DEVELOPMENT REVIEW BOARD REPORT

Hazel & Azure - Request for approval of hardscape and landscape plans for the canal bank improvements associated with the Hazel & Azure mixed-use development (37-DR-2021#2 (37-DR-2021).

Scottsdale Development Review Board Report | Case No. 37-DR-2021#2

Subject: Canal Bank Improvements

STAFF EXHIBIT:REQUIRED CANAL BANK IMPROVEMENTS, PER ORD. NO. 3909. 1 of 2

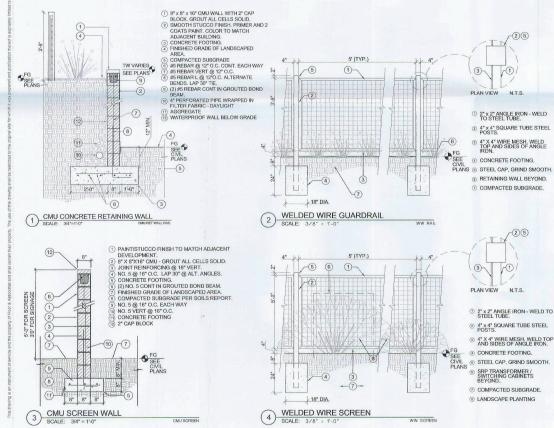
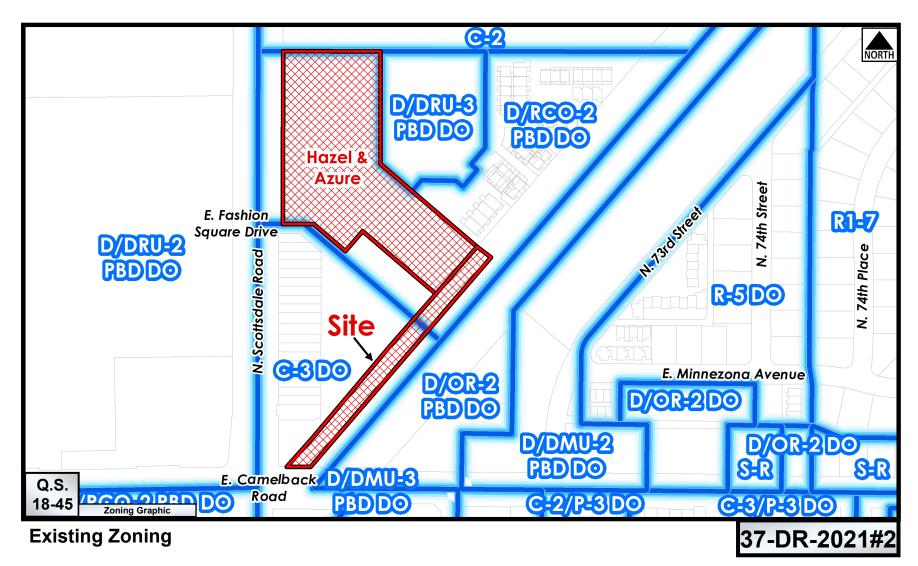
As discussed, Hazel and Azures current canal bank proposal is unacceptable as it does not meet their stipulation from 2007 (see attached). Please note that the approved plan already considered the box culvert inlet condition and proposed a short retaining wall along the outside edge of the canal ROW. Even if FCD does not allow a small retaining wall in their ROW, there's plenty of room to widen the top of bank and simply slope the outer edge to catch grade, as depicted on the image below. Another option is to raise the box culvert inlet. Have either of these options been explored? I understand that they may have run into resistance from SRP/FCD but defaulting to leaving this segment narrow in lieu of exploring all options is not right or in the best interest of the City, the community &/or the surrounding properties. Nobody bothered to reach out to us. As discussed, it is critical to provide the full width improvements, not only from an esthetic value at this key location, but also to create enough space for the eventual bridge to land that will be extended across the canal from our proposed Edition hotel to the east.

In summary, there are solutions that do not appear to have been considered. I suggest a stipulation that requires them to either comply with the full-width requirements, or suggest you continue the case to allow time for proper coordination between vested parties. Unfortunately, the first we heard of their intent to do something other than what was approved, is from your email of yesterday.
